**PERMIT REPORT**

Re: Permit 21-515; City of Minneapolis Park Lane Sanitary Sewer Replacement

Variance Supplement

Subject: Variance Supplement: City of Minneapolis Surface Waters and Sewers
Park Lane Sanitary & Storm Sewer Improvements

PIPE INSULATION AT CHANNEL CROSSING CONCRETE ENCASEMENT CROSS SECTION

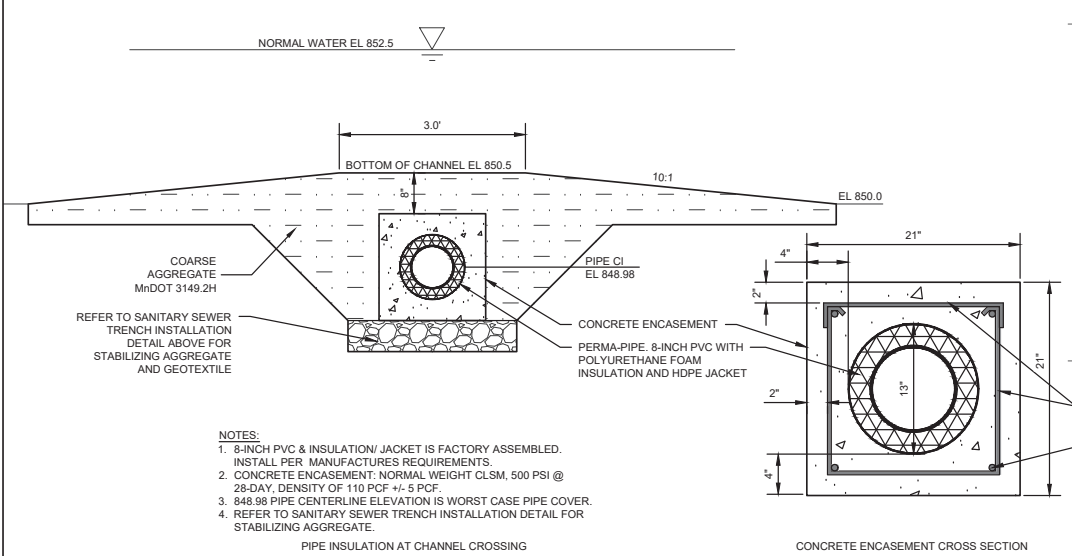
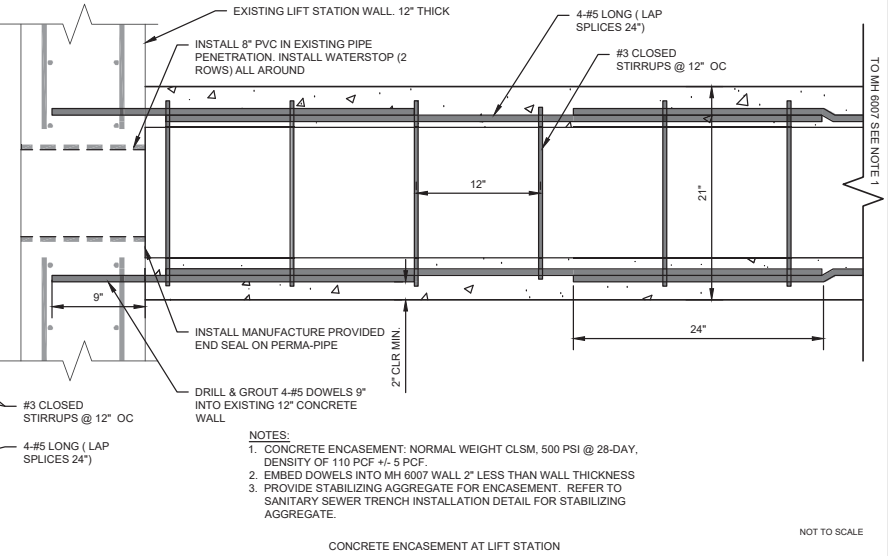
The Applicant proposes to replace the existing sewer pipe with a new pipe in the same location. The material of the pipe would change from cast iron to polyvinyl chloride (PVC) surrounded by polyurethane foam insulation, encased in concrete. As the existing pipe is below the bottom of the waterbody by 7-inches or less, the applicant proposed to rebury the pipe in its current location and re-cover the pipe using coarse aggregate over the top of it to insulate the pipe and to attempt to meet the Rule's 3-foot (36-inches) minimum clearance requirement. As a result, the pipe would be placed 14-inches below the bottom of the waterbody; which is a shortfall of 21-inches from the 36-inch requirement. By providing 8-inches of coverage over the replacement pipe, the waterbody would result in a depth of 2-feet for water conveyance and navigational purposes.

- The polyethylene jacketed polyurethane insulated pipe (Perma-Pipe) provides a low thermal conductivity (K-factor) and is more effective than the more frequent board insulation installed above the pipe crown. The insulation will minimize heat transfer between the sewer and the channel, better allowing the channel to freeze over (see Figure 3 for more details).

SWS is hereby requesting a variance for the reconstruction of the 8-inch sanitary sewer pipe as outlined in Alternative 3. As presented, the crossing will provide 14 inches of clearance between the top of pipe and the channel bottom.
